Program Bulletin

SB-10056450-4367

SUBJECT: Illuminated Door Handles

MODELS: 2015 Cadillac Escalade, Escalade ESV
Equipped with 1SC Package

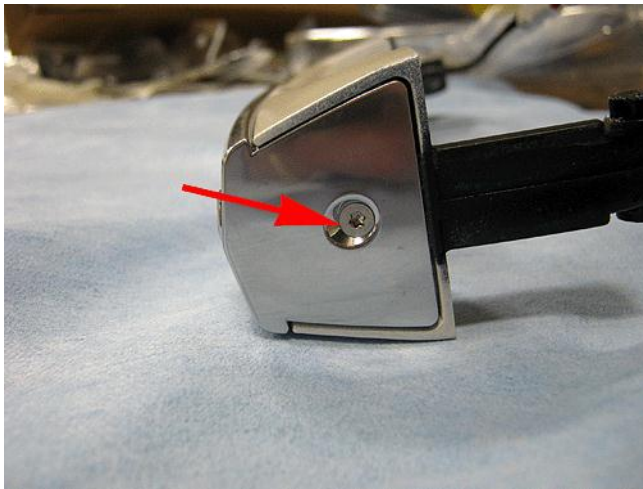
1. Remove the two front door outside handles. Refer to *Front Side Door Outside Handle Replacement (with ATH)* in SI.

NOTE: The left front door may have an anti-tamper bracket around the lock. This is indicated by two screws in the door frame area. Remove these screws along with one internal fastener and reposition the bracket to allow access to the door lock cylinder screw.

3975437

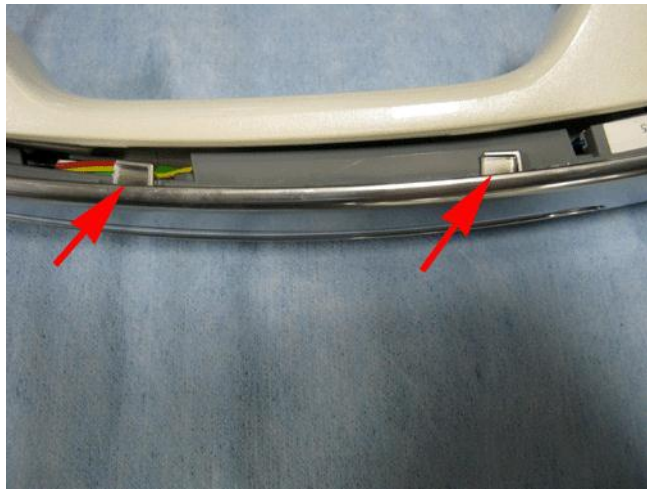
3. Remove the fastener at the rear of the handle.
